Safety Analysis of Epoxy Curing Oven
11 January, 2013
Richard Abbott, LIGO, Caltech
E13000035-v1

I. Synopsis

Figure 2, Top Front View of Controller. Ground wire is bonded to metal box as seen along the rear wall. Fuses seen on the front panel individually protect the oven heater circuit, and the commercial temperature controller

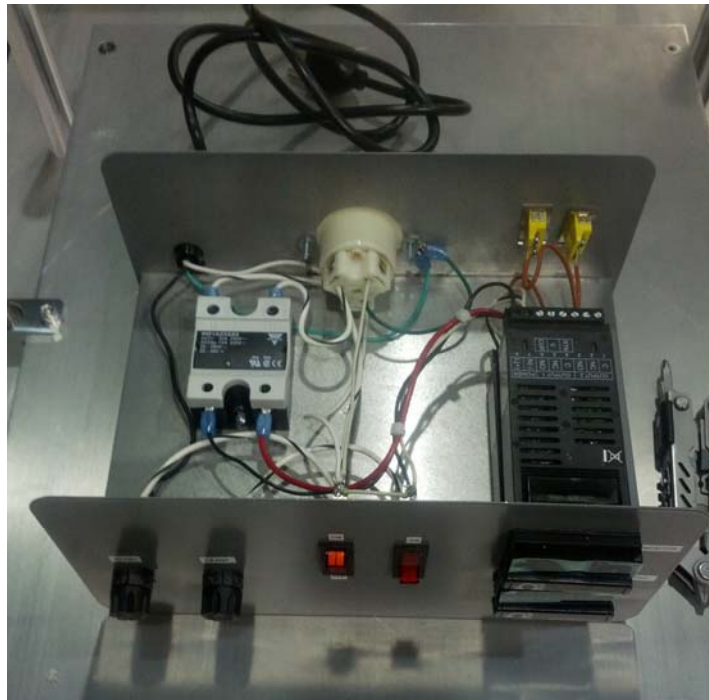
B. An inspection was conducted by Richard McCarthy upon receipt of the oven at LHO. Richard noted several discrepancies, and communicated them by email. Shown below is a summary of Richard's observations.

1. The oven and its associated controller had not been inspected per the LIGO EEIP program.
2. For conditions wherein the oven must be operated above the thermal cutout setpoint, (40 degrees C.) a technician must bypass the thermal switch. There was insufficient instruction given to adequately inform a technician of the hazards associated with the task.
3. The insulation on the thermal switch can be easily removed, and should be better labeled to identify the hazardous voltages
4. Richard inquired as to whether the oven assembly and associated controller had been properly electrically grounded.

- D. No further action is required to ground the components of the oven and controller. Sufficient electrical bonding exists in the design.
- E. The overall construction of the controller and oven are consistent with reasonable engineering practice. No further construction mitigation is required.
